Access Compliance Report

Public Rights-of-Way

(Curb Ramps)

Intersection ID: 15029	Main Street: CAMPBELL_DR	Cross Street: GREENBROOK_DR	Location:	N
ADA ID: EF5F9F8D295C	Ramp Type: BlendTrans2	Initial Pass/Fail: Pass	Overall Compliance: No	Severity Score: 0
Codes/Mitigation Info/Possible Solution		Field Measurements/Component Compliance

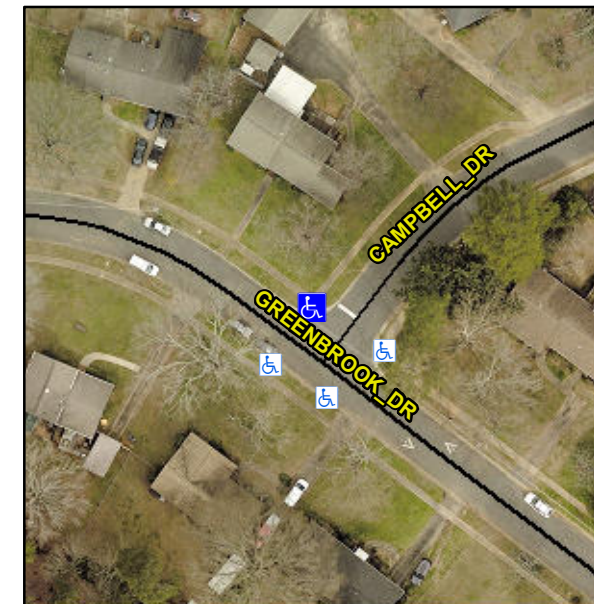
Not Found, R305.2, R302.7

Compliance	Description	Data	Compliance	Description	Data
N/A	Ramp Length (in)	60.0	Yes	BlendTrans Slope (%)	3.7
Yes	Ramp Width (in)	48.0	Yes	BlendTrans XSlope (%)	1.1
N/A	Flare Type LT	Sloped	N/A	Flare Type RT	Sloped
N/A	Flare Slope LT (%)	2.9	N/A	Flare Slope RT (%)	4.2
N/A	Flare Traversable LT?	No	N/A	Flare Traversable RT?	No
N/A	Landing Length (in)	N/A	Yes	DWS Provided?	Yes
N/A	Landing Width (in)	N/A	Yes	DWS Contrast?	Yes
N/A	Landing Slope (%)	N/A	Yes	DWS Length (in)	25.5
N/A	Landing X Slope (%)	N/A	Yes	DWS Full Width?	Yes
N/A	Landing Curb? (Y/N)	No	No	DWS Offset (in)	2.5
N/A	Shared Landing?	No			
No	Gutter Ponding?	Yes	Yes	Gutter Slope (%)	0.0
Yes	Gutter Lip Ht (in)	0.0	Yes	Gutter X Slope (%)	1.6
N/A	Painted X Walk1?	No	N/A	Painted X Walk2?	No
	X Walk 1 Direction	To SW		X Walk 2 Direction	To SE
	X Walk 1 Width (in)	N/A		X Walk 2 Width (in)	N/A
	X Walk 1 Slope (%)	4.7		X Walk 2 Slope (%)	5.0
	X Walk 1 X Slope (%)	3.5		X Walk 2 X Slope (%)	1.5

N/A	Ramp inside XWalk1?	N/A	N/A	Ramp inside XWalk2?	N/A
	Road Slope (%)	0.4		Clear Space?	Yes
	Road X Slope (%)	6.2	N/A	Clear Space to XWalk (in)	N/A
Yes	Any Obstructions?	No	Yes	Storm Grate/Utility Hazard?	No
	Obstruction Type			Storm Grate/Utility Type	
		N/A			N/A
			Yes	Surface Condition? (G/P)	Good
			No	Curb Slope (%)	17.2

Remove & Replace Curb Ramp With Two New Directional Ramps or Equivalent.
